Notes of GARD visit to SESRO Clay Compaction Trial site 20th May 2025

Summary

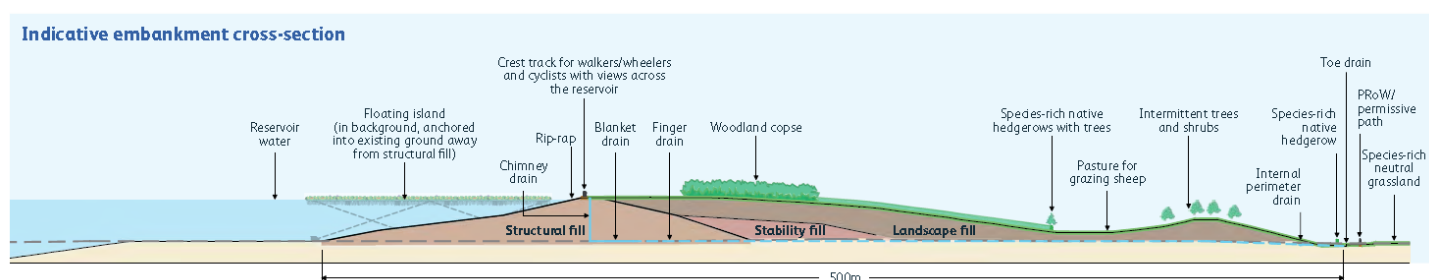
described the dam as having a clay core with supporting shoulders. We were told on site that the design had always assumed a clay core and supporting shoulders, but we were not provided any further information on the planned zoning of the earthfill or shown a cross-section. The design with a separate clay core and shoulders is not consistent with the following documents:

- The 2007 design report which made no mention of a clay core and showed the whole dam as “compacted clay fill”¹
- Appendix 3 to Jacobs 2008 engineering report which showed an upstream zone and a downstream zone separated by a chimney drain – no sign of a clay core²
- SESRO Gate 2 concept design report and cross-section did not show a clay core³
- The ‘Technical brochure’ for the first pre-DCO consultation did not show a clay core and a cross-section showed a chimney drain located in the centre of the cross-section, where a clay core would be, if one had been planned (see diagram below)

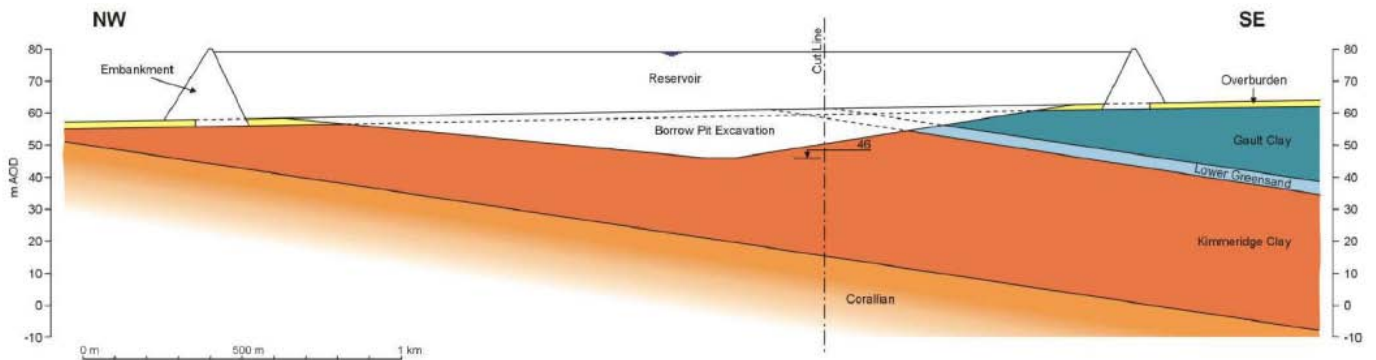
The TW liaison officer asserted that it had been a separate clay core embankment design in the pre-DCO consultation in summer 2024. She did not change her view even when MG read the appropriate extract from the consultation document which made no mention of a separate clay core and shoulders and showed the cross-section below⁴:

This diagram shows a homogeneous ‘structural fill’ and a chimney drain located in the in the centre of the dam – where the clay core would be if the dam is designed with a clay core and separate shoulders.

“The design change from a homogenous internal design for the reservoir embankment to a clay core and shoulders formed part of our design development following on from Gate 2. This detailed design change is not as a result of the CCT trial. An explanation of the clay core and shoulder design will be presented in our Gate 3 reports.”
